Hillingdon

Outline Fire Strategy – Rev E

OF-OFS-3671-01-E

Appendix A – Drawing Comments

1 Building 12 - Ground Floor Plan
1 : 200

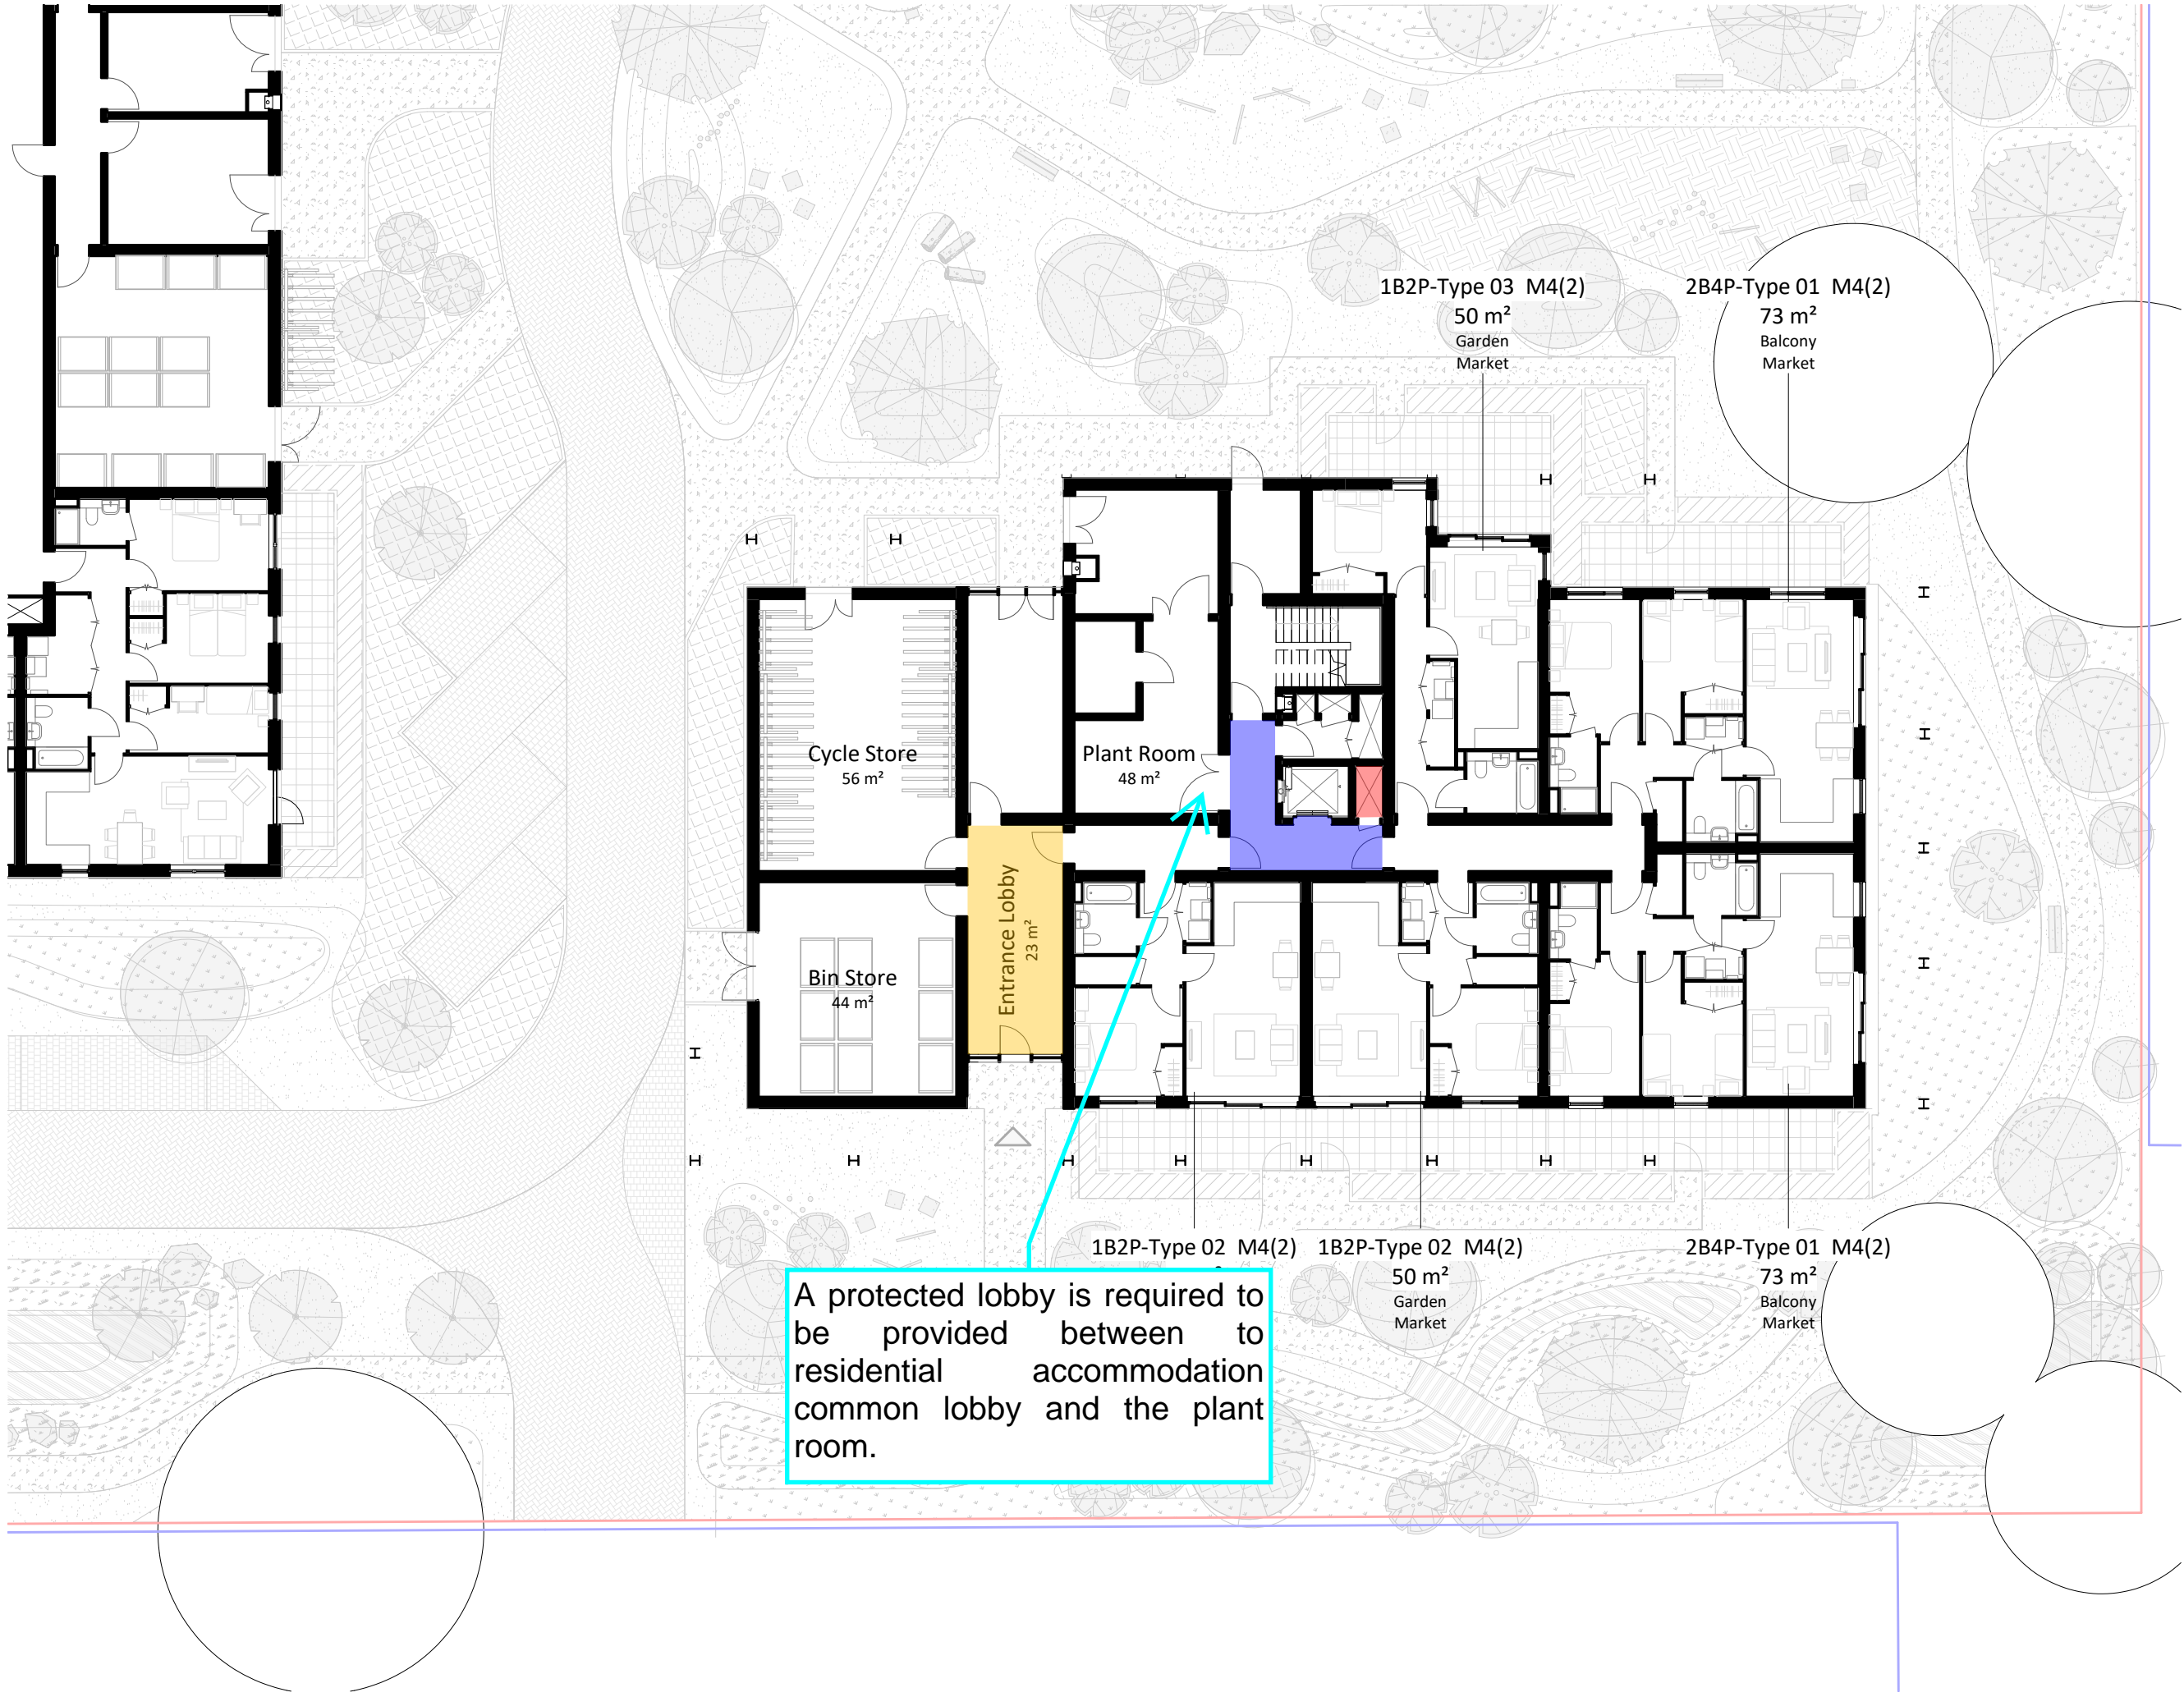
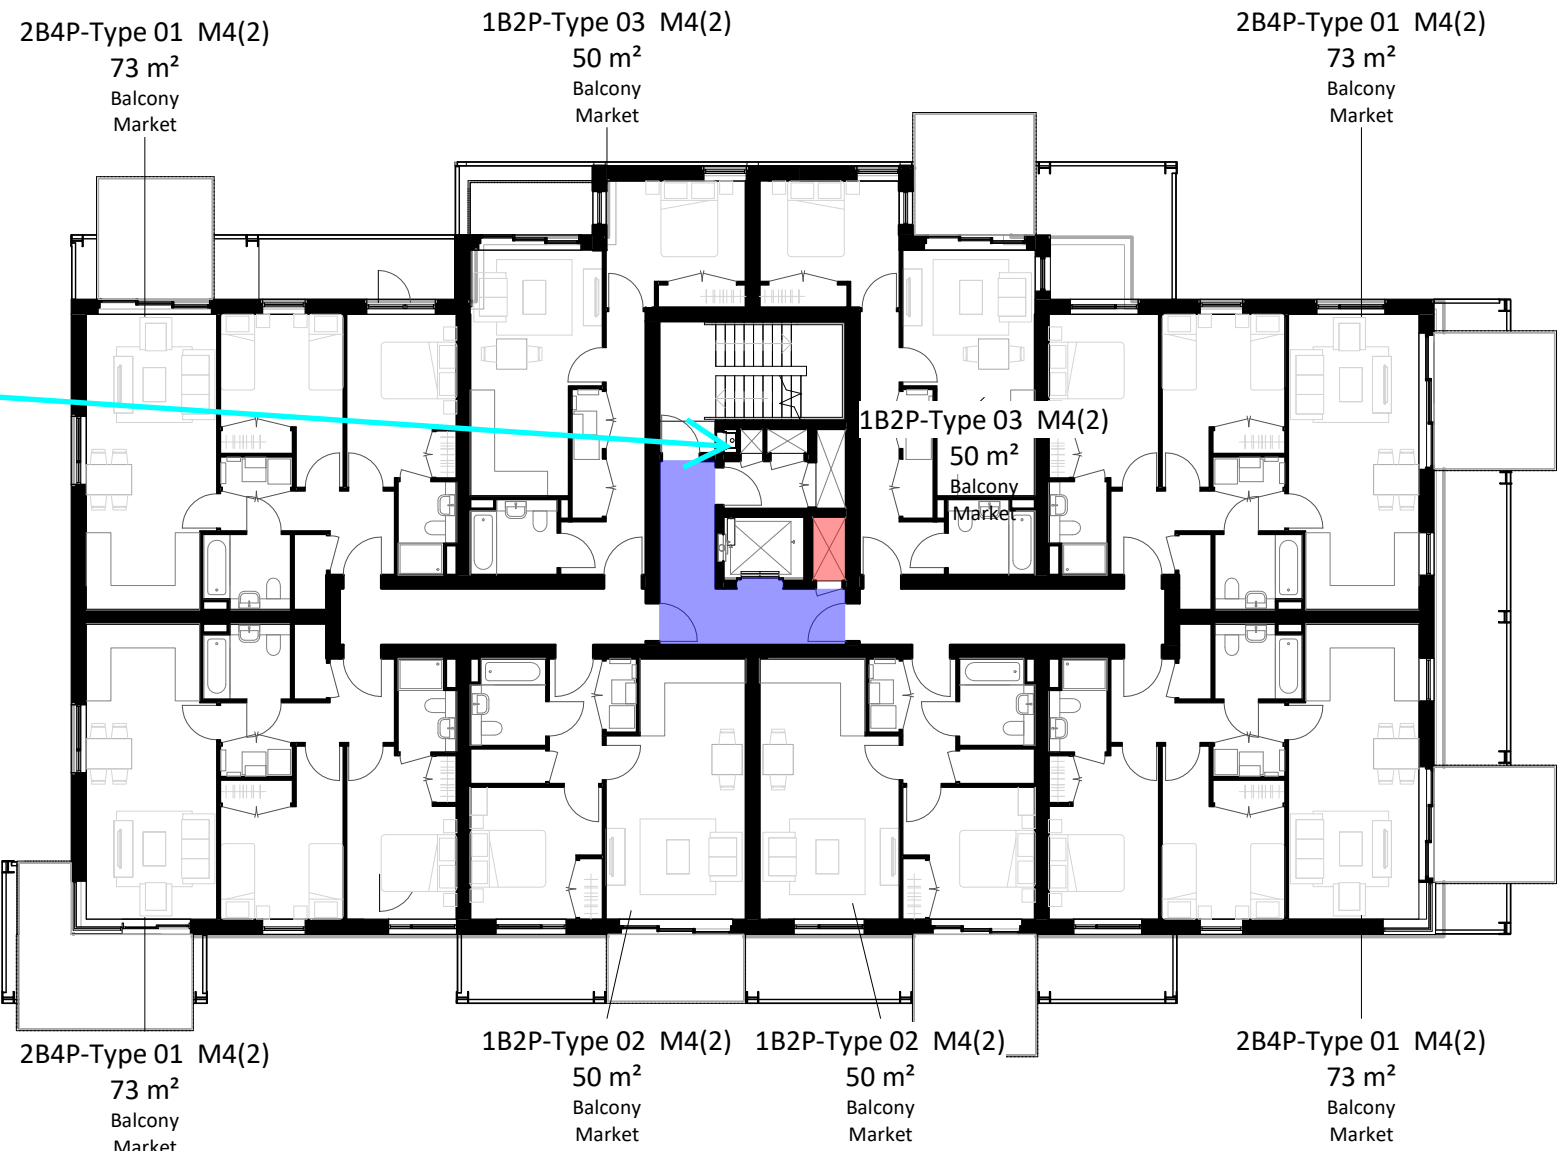
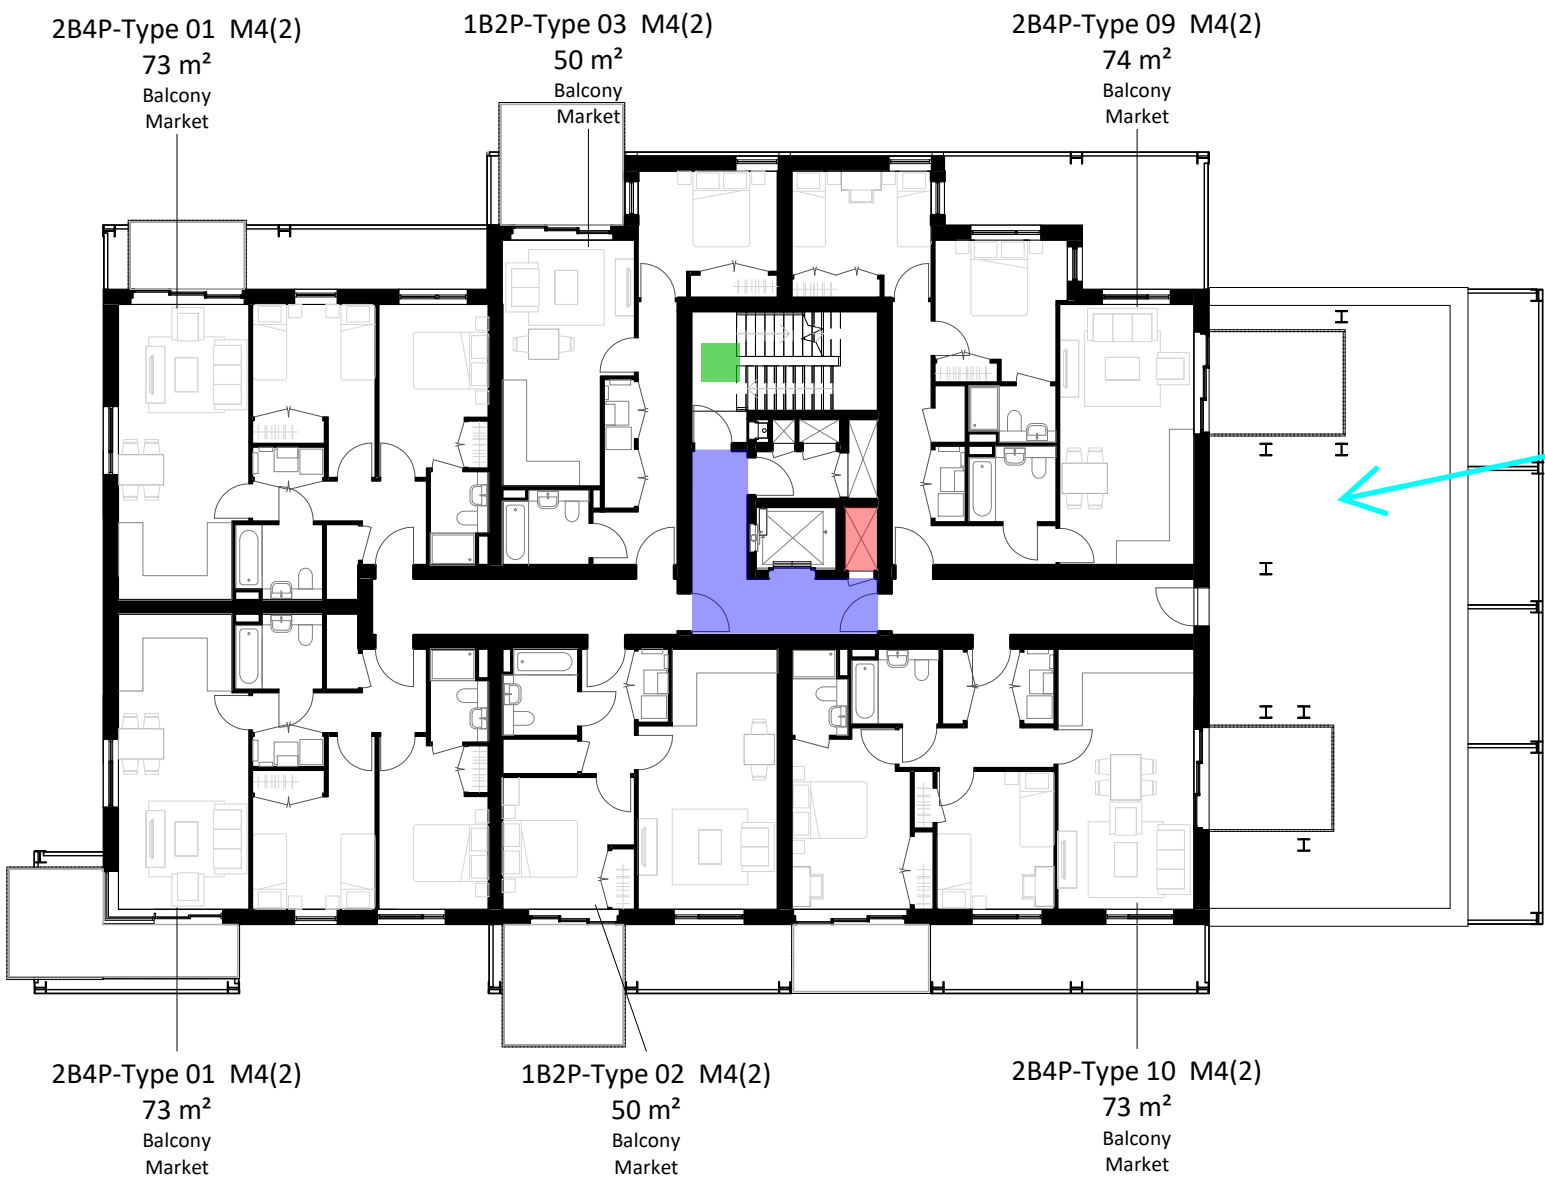
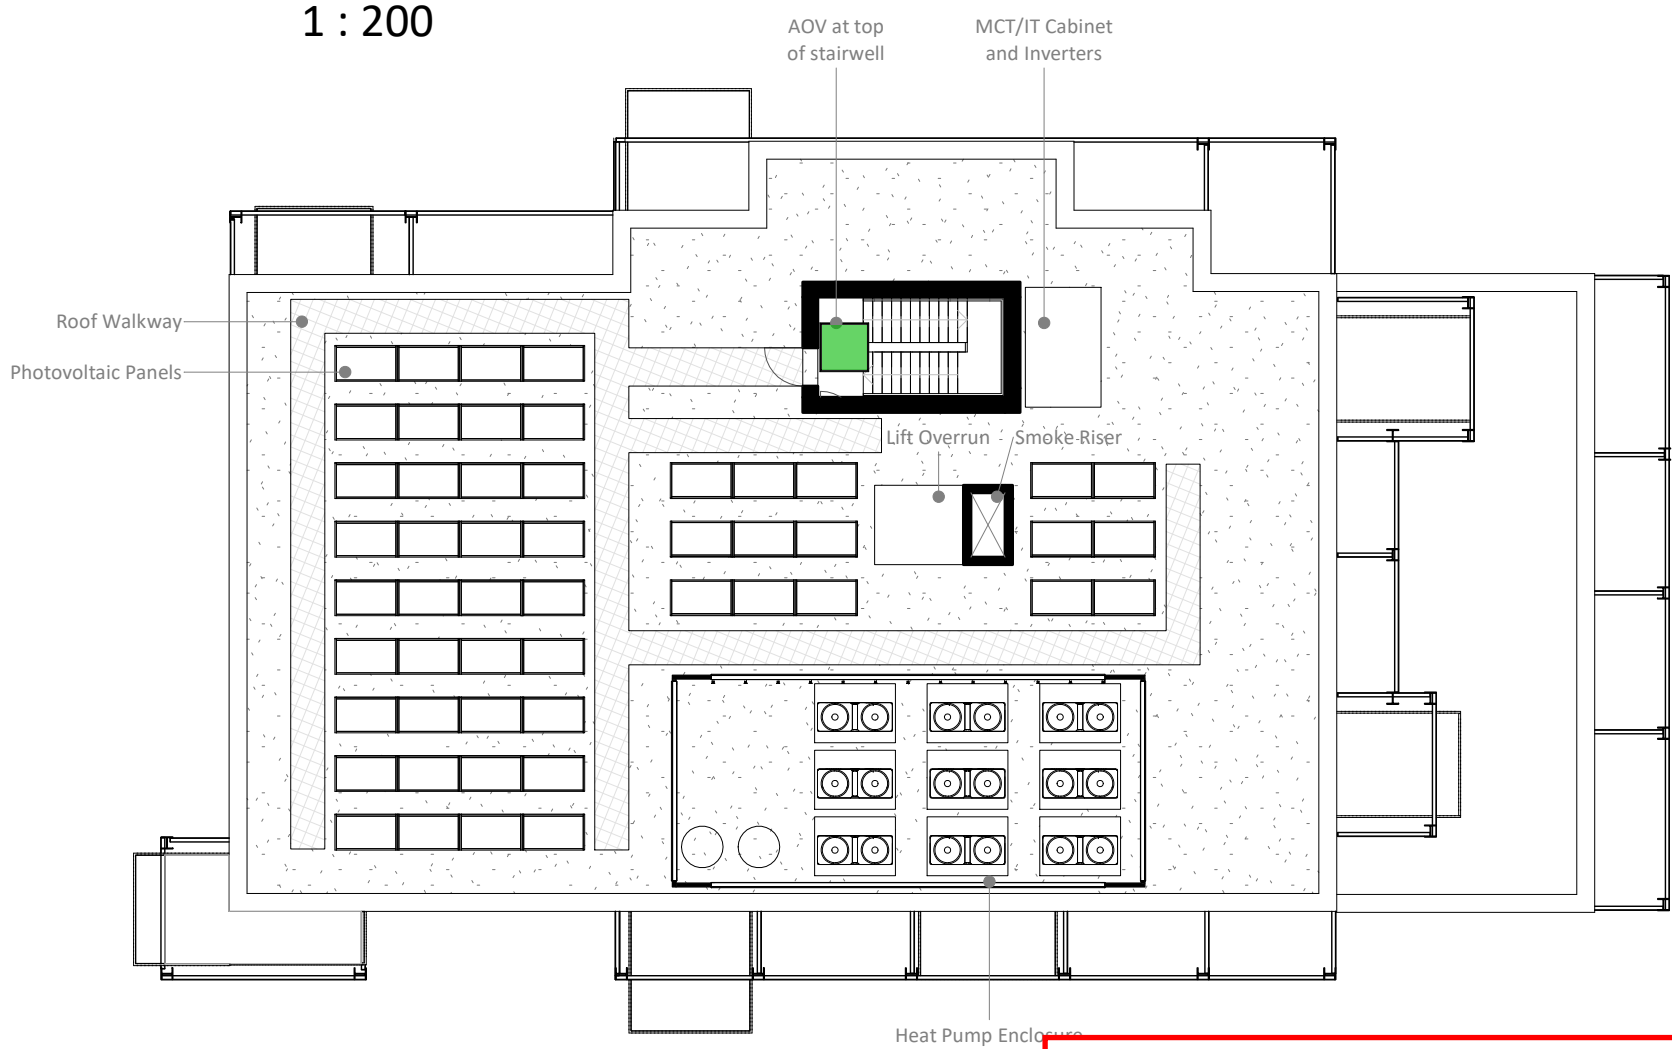
To be noted, if the service riser is to only contain water services or metal ventilation ductwork from the ground floor, it is considered a limited fire hazard. As such, this riser shaft may be located in the staircase lobby.

To be noted, the government have stated from May 2020, all new building's over 11m in height are required to be provided with sprinklers, see Section 9.
